## Logan-Union-Champaign regional planning commission

### Zoning & Subdivision Committee Thursday, June 11, 2015, 12:30 pm

### Staff Report – Darby Braeside

<b>Staff Analysis:</b>	<p>This Preliminary Plat is for the Darby Braeside Development. A new Preliminary Plat was required because the 2008 approval, 2010 extension, and 2012 extension all expired in August 2014. This subdivision proposes 48 lots for single family residential development on a total of 152.867 acres. In addition, 36.72 acres in open space is proposed. The proposed method of supplying sanitary waste disposal is private, on site sewer treatment systems. The proposed method of supplying water service is private, on site wells.</p> <p>• <b>Union County Engineer's Office</b></p> <ul style="list-style-type: none"><li>○ In a letter dated 06-05-15, the Union County Engineer's Office recommended approval with modifications that must be addressed in the final Construction Drawings and Final Plat. Some of those modifications are summarized as follows:<ul style="list-style-type: none"><li>✓ Zoning will need to be approved through Jerome Township <i>prior</i> to the approval to the Final Plat. Note: Jerome Township revise

TITLE SHEET.

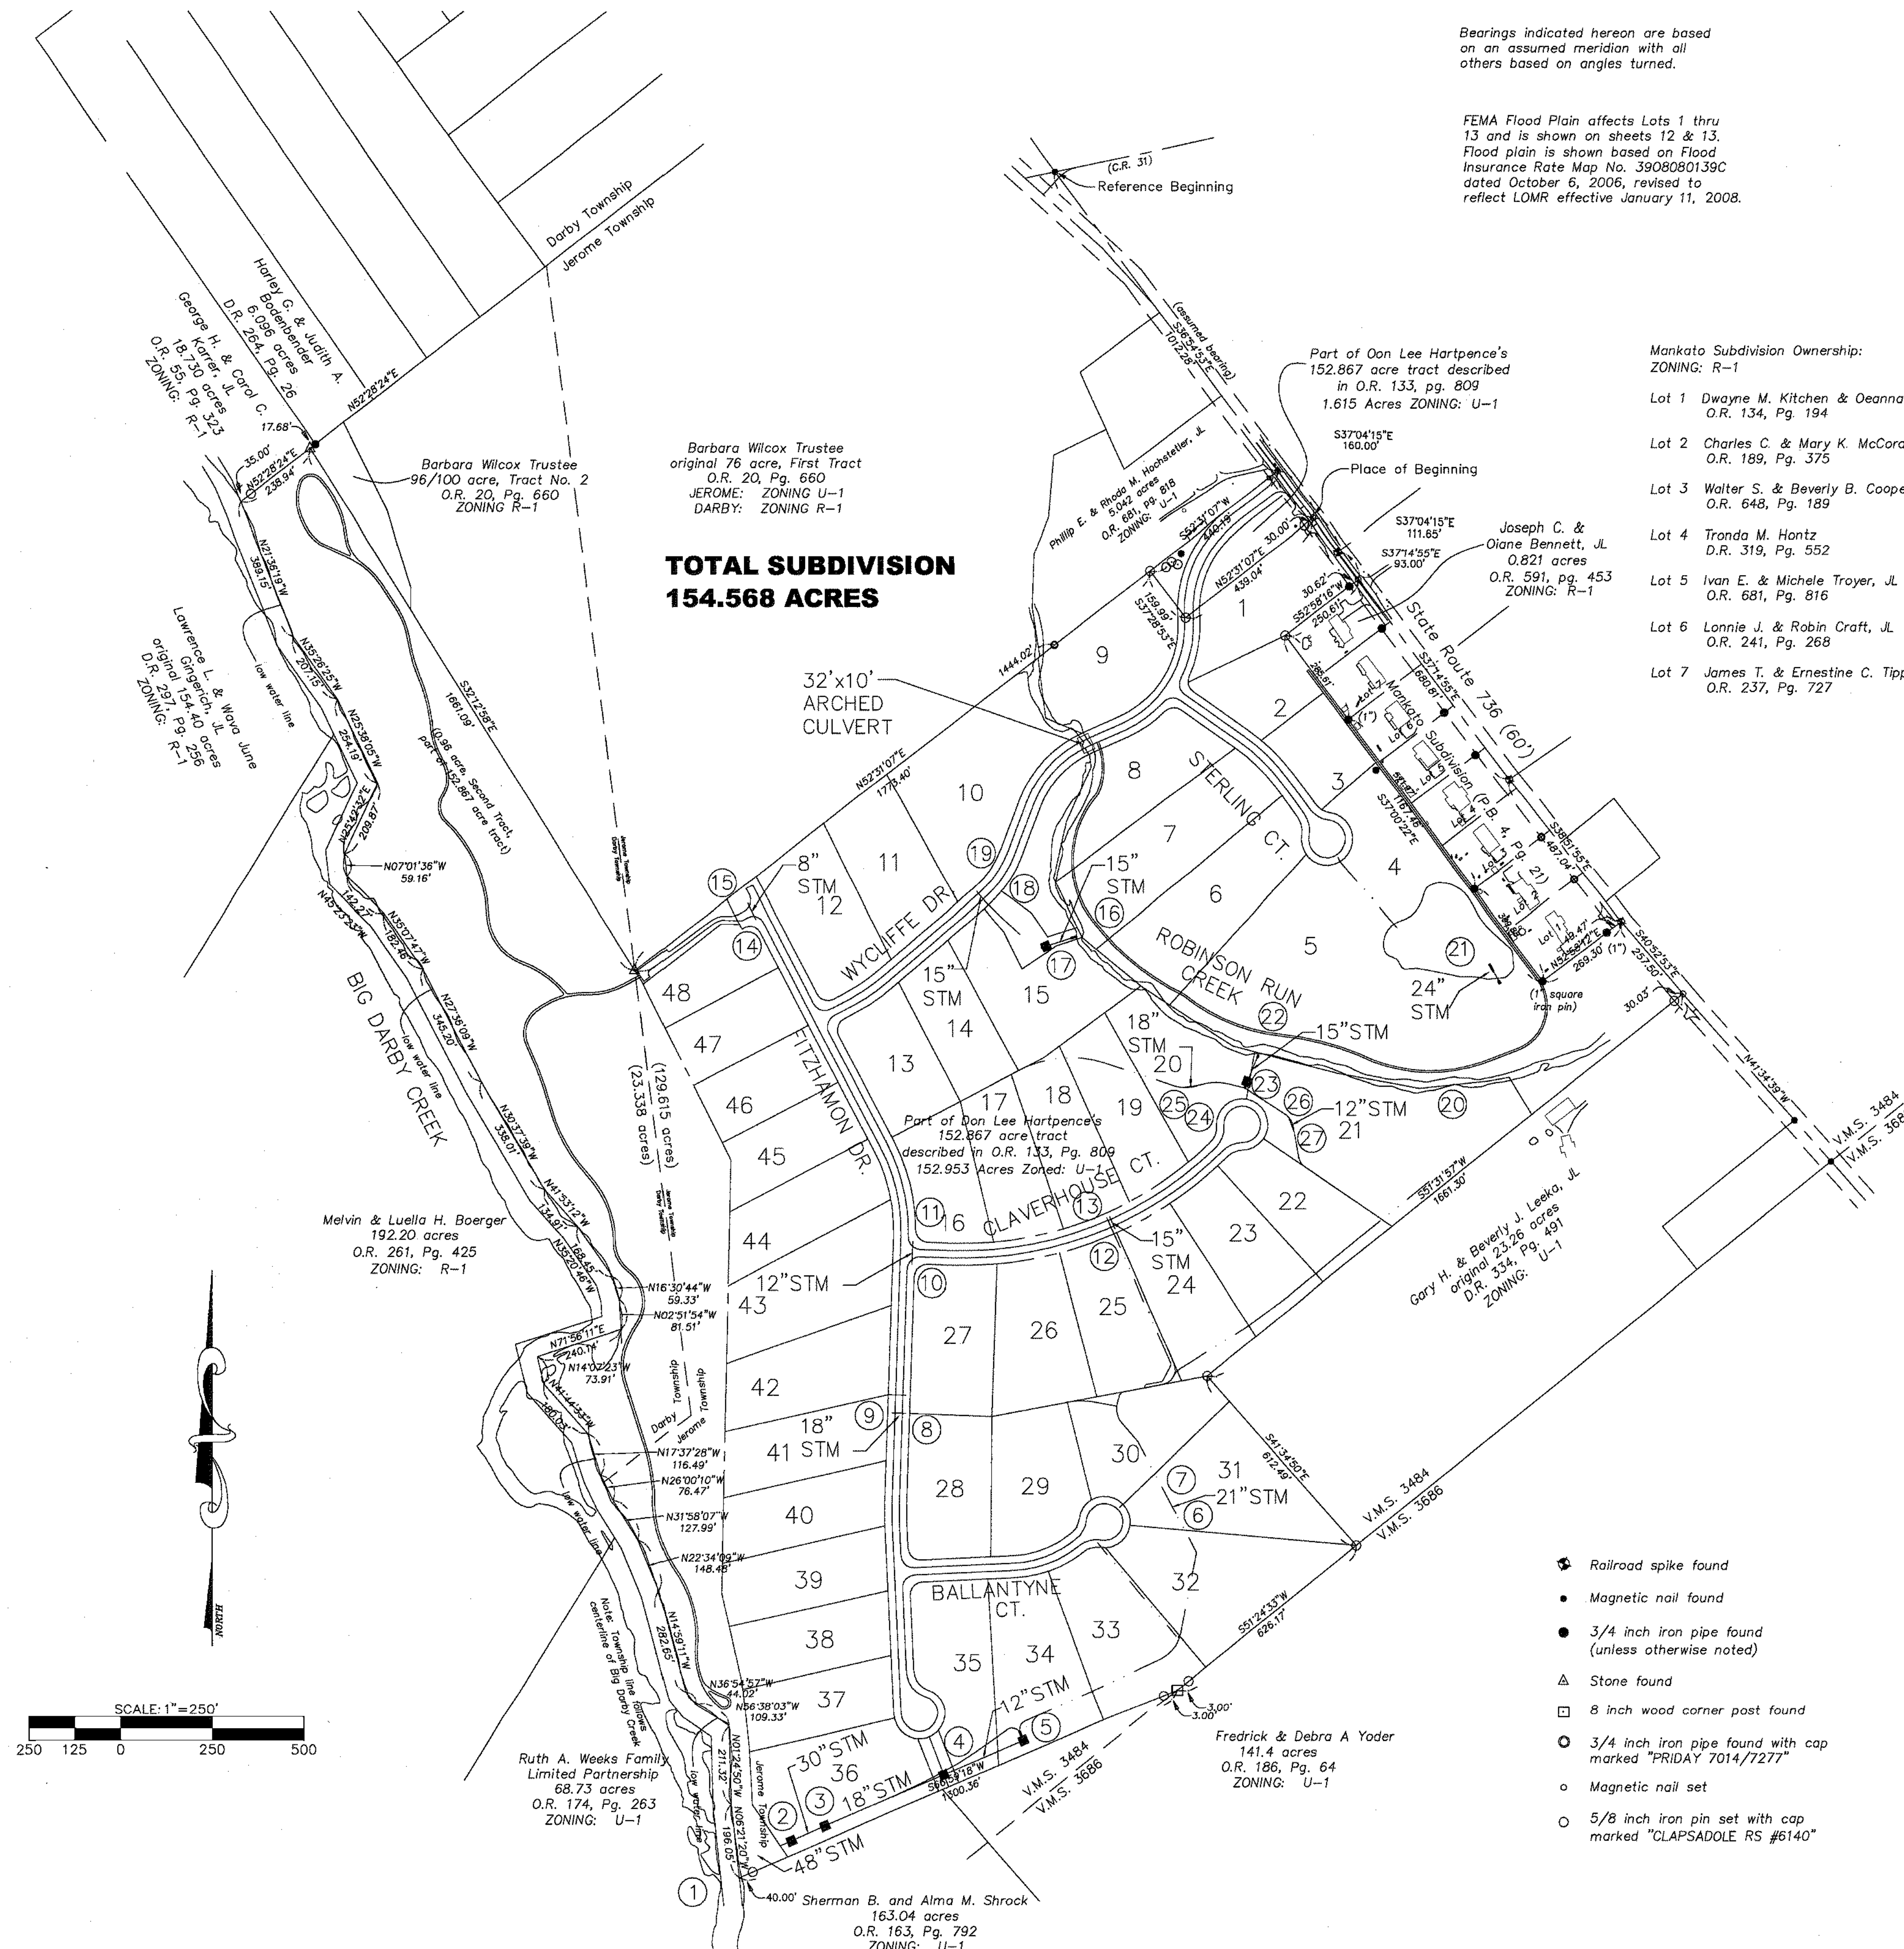
1) Drawing 1/30 – Title Sheet

- Average of 0.31 Lots / Acre
  - Or
  - 3.22 Acres / Lot
- a) Will roadways be dedicated public roadways maintained by a governmental authority?
- b) Request 10 ft easement adjacent to Mankato Subdivision. Easement to be used to serve lots 1 through 4 from Mankato Subdivision facilities. URE propose to replace existing overhead with underground facilities.

- c) Proposed to provide one side of a loop development with a tap between lots 1 and 2 from Mankato Subdivision circuit.
- d) Propose to serve the majority of lots from road with offsets to transformer locations closer to the homes.
